ORDINANCE NO. 3932

AN ORDINANCE OF THE CITY COUNCIL OF THE CITY OF CHANDLER, ARIZONA, AMENDING SECTION 43-5.1 OF CHAPTER 43 OF CHANDLER CITY CODE; RELATING TO THE CITY OF CHANDLER STANDARD DETAILS AND SPECIFICATIONS.

SUBJECT: May 2008 Amendment to the Engineering Standard Details and Specifications (2007 Edition)

DETAIL NO. <b style="font-size: 1.5em;">C-404 PAGE 1 OF 12	 CITY OF CHANDLER STANDARD DETAIL	<b style="font-size: 1.2em;">RECLAIMED WATER SERVICE CONNECTIONS	APPROVED: _____ CITY ENGINEER DATE: _____	DETAIL NO. <b style="font-size: 1.5em;">C-404 PAGE 1 OF 12
--	---	---	---	--

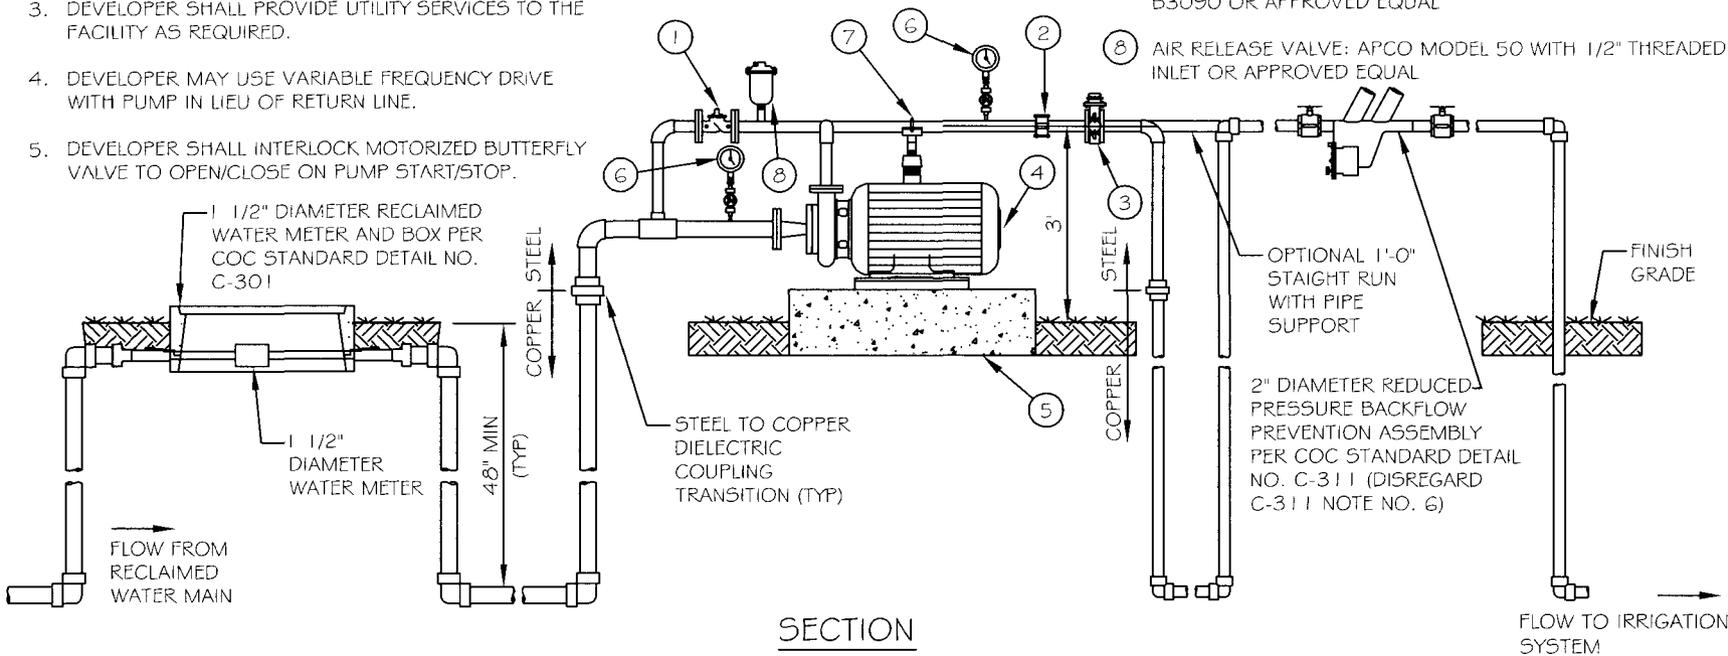
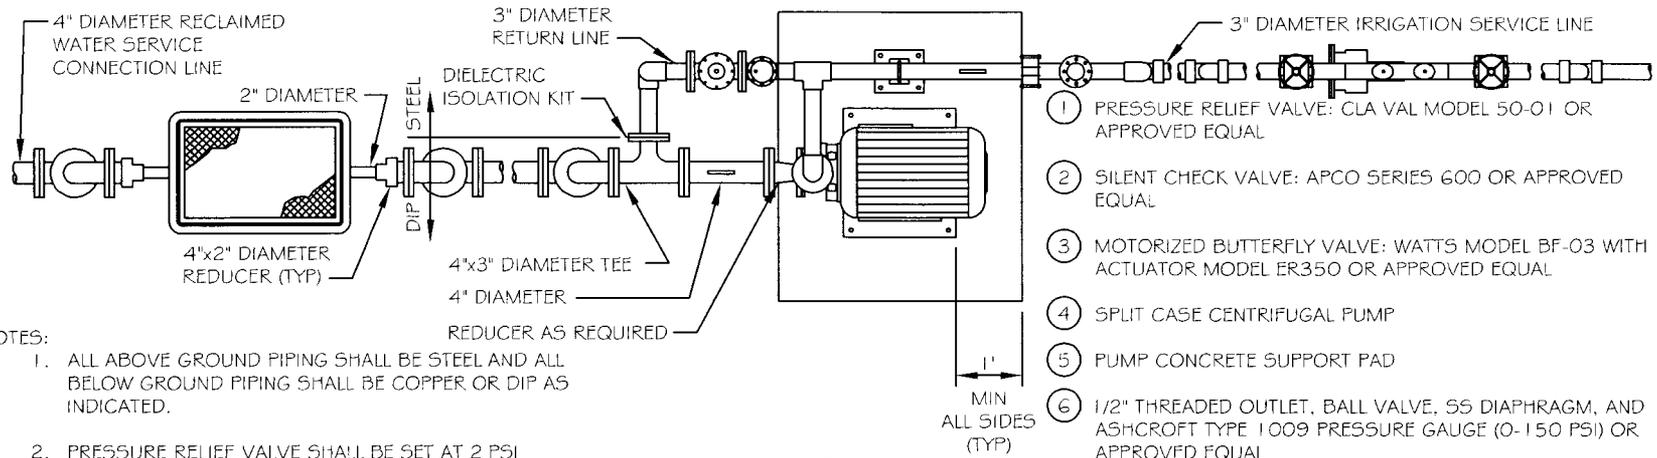
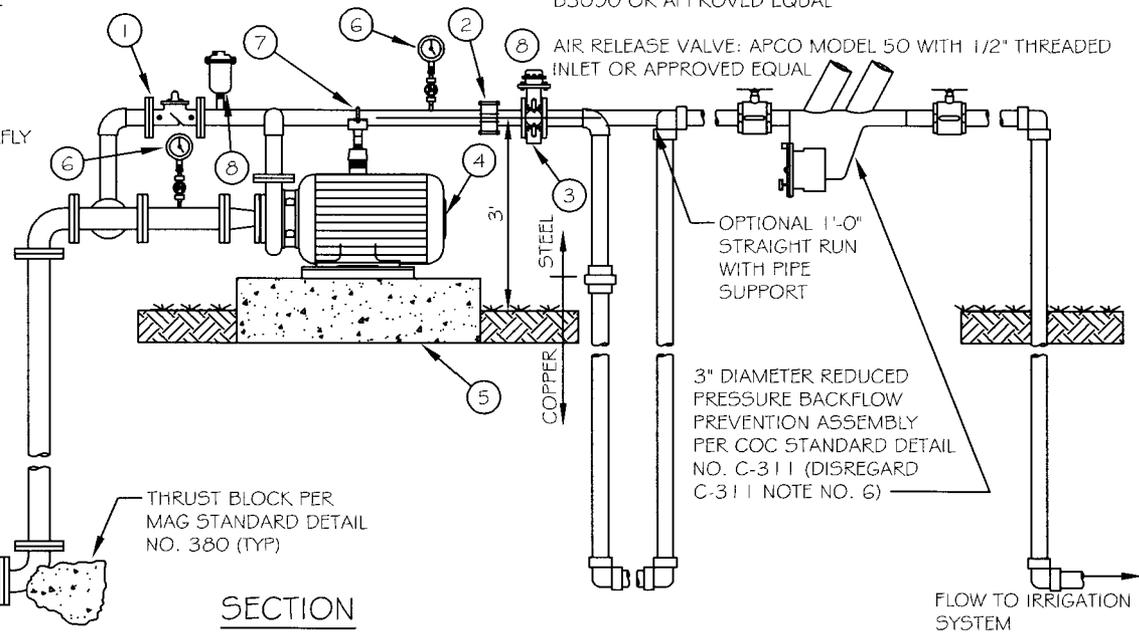
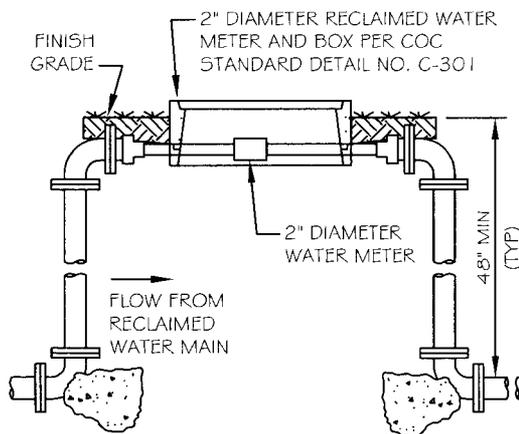
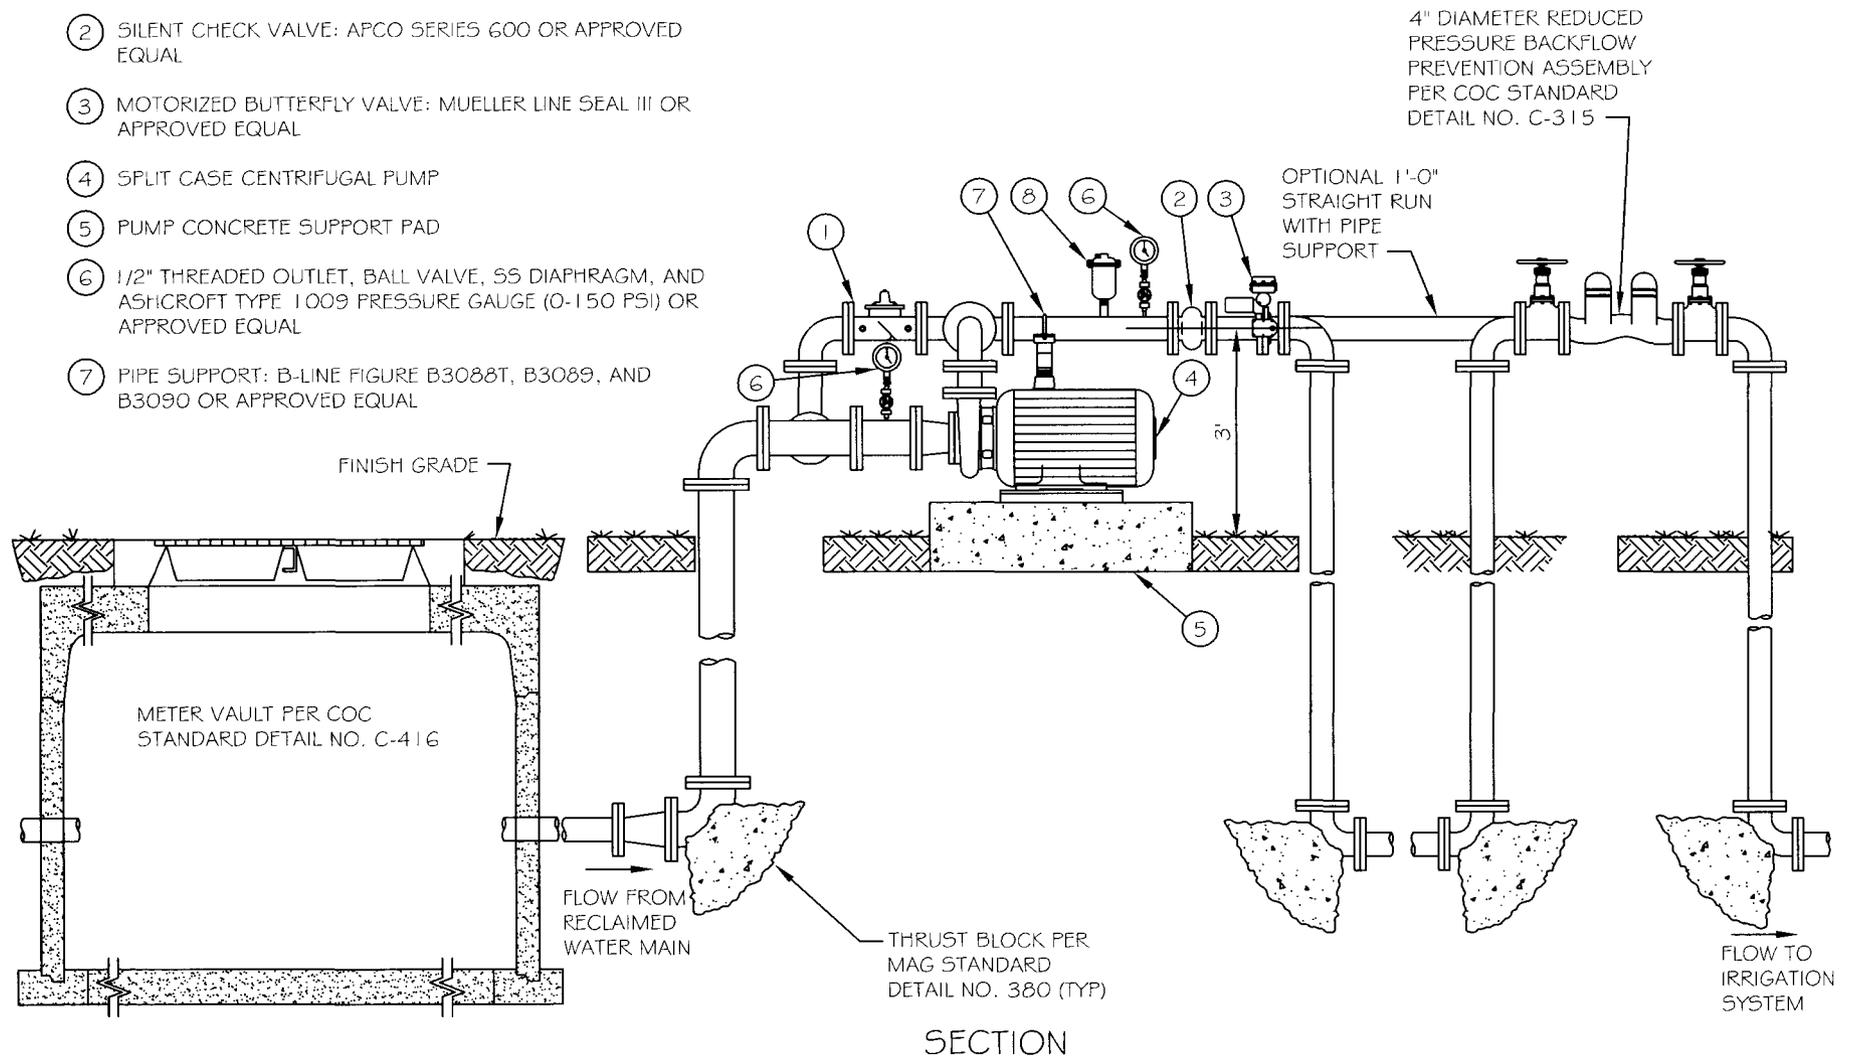
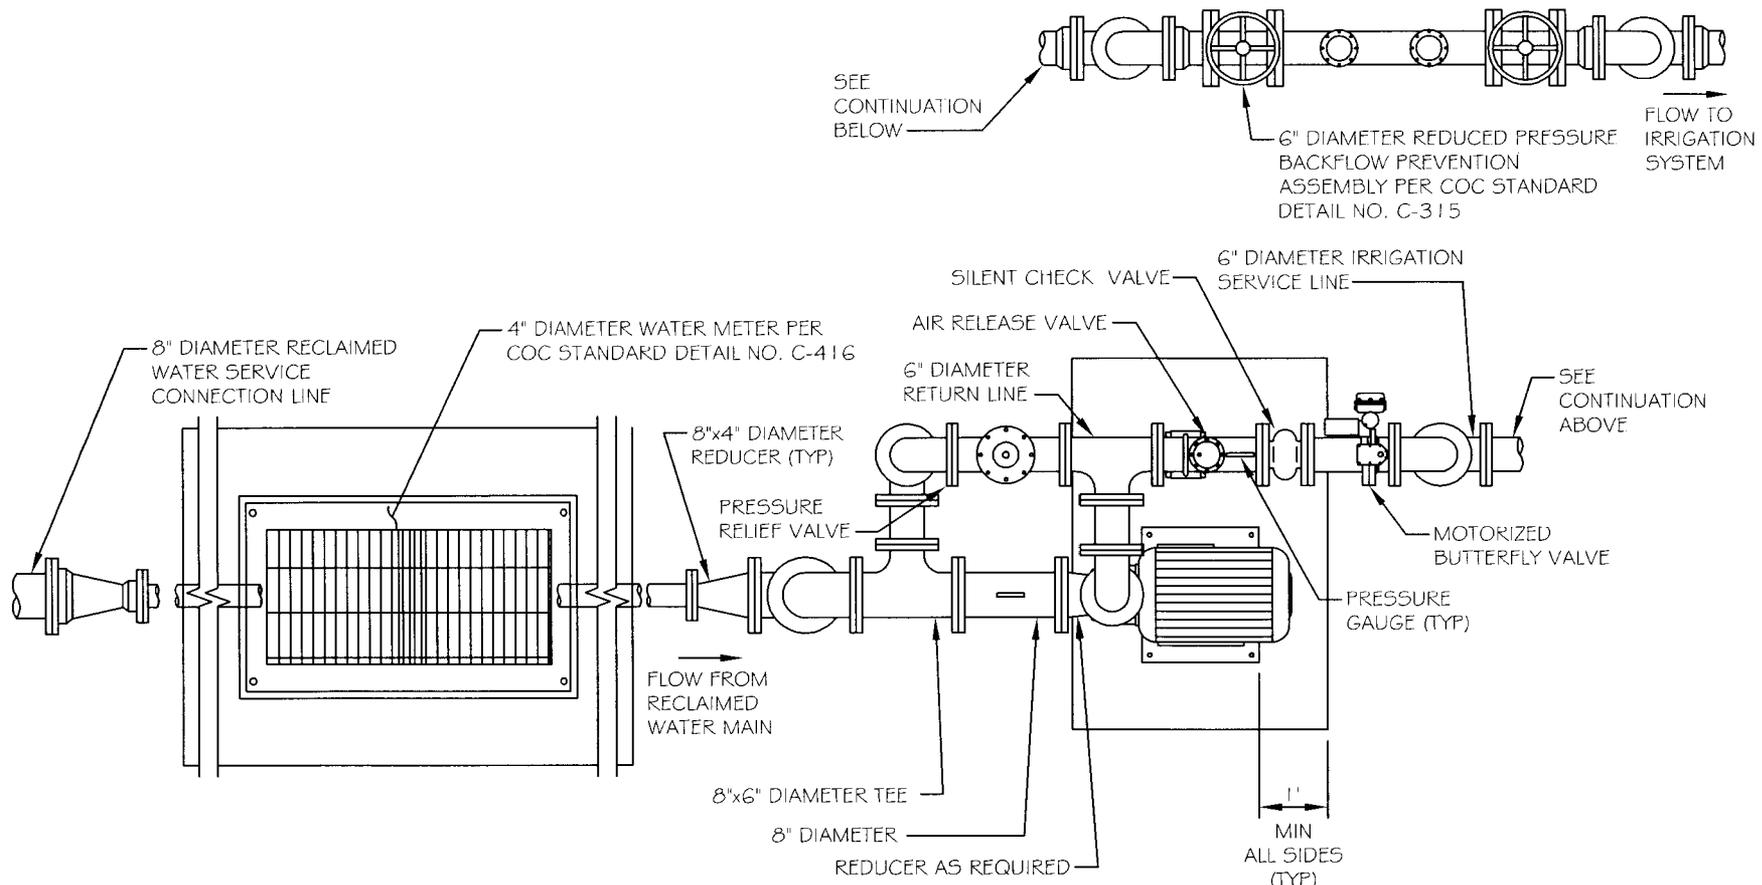
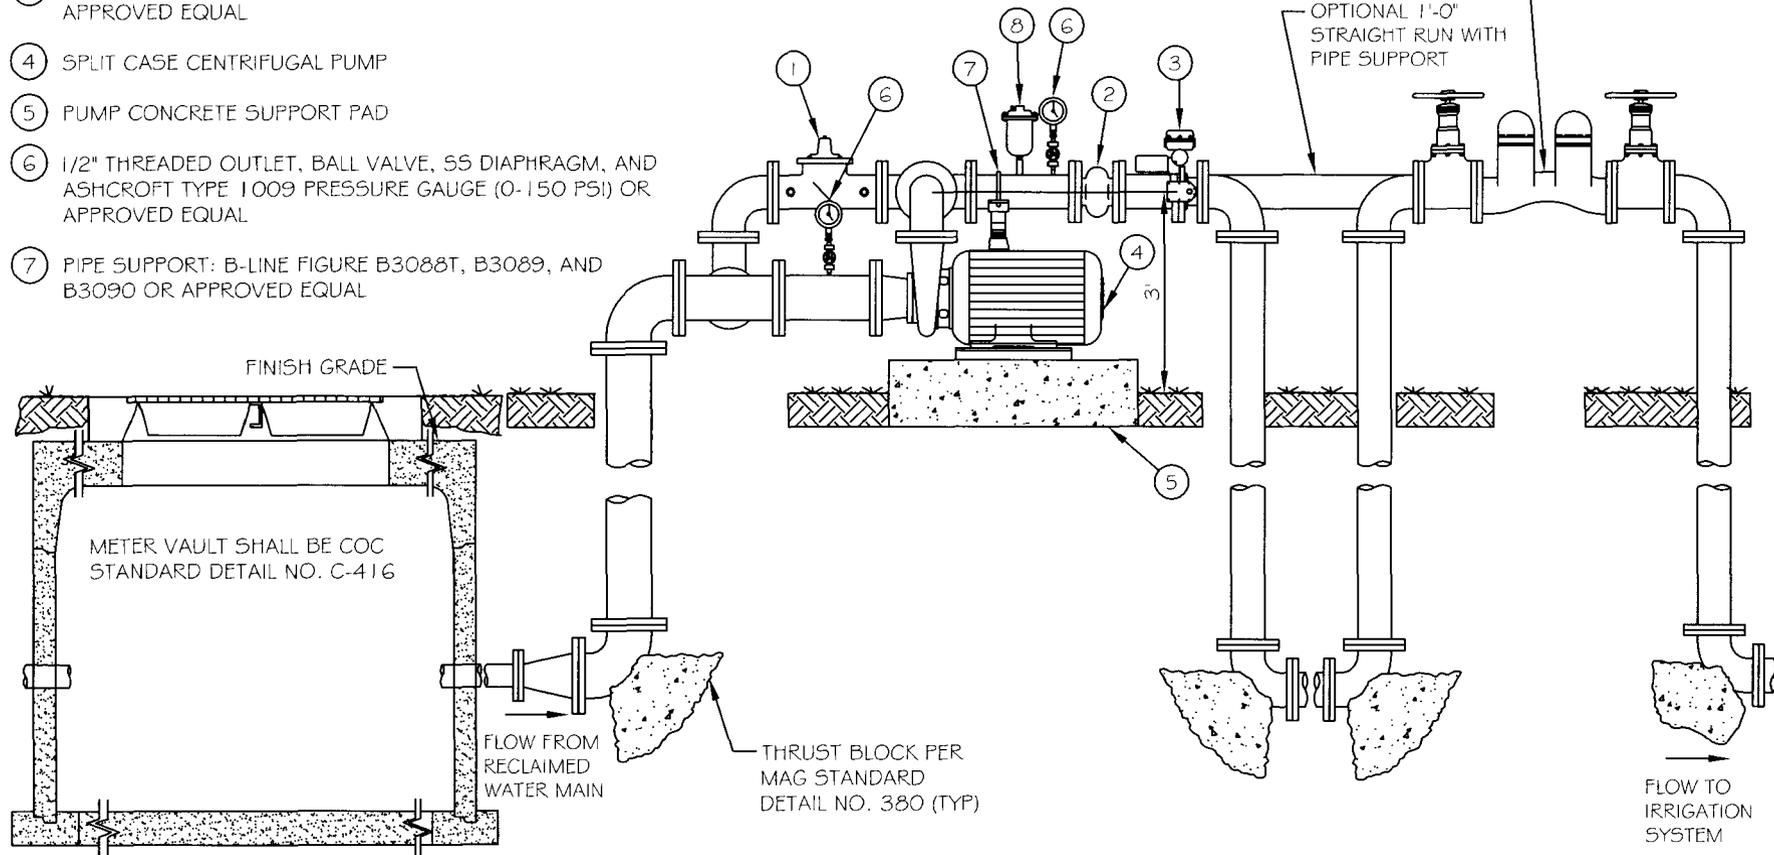
- Detail C-404 (PG 1-12) – revisions and additional standard details needed for reclaimed water services to accommodate various meter sizes and flow requirements.
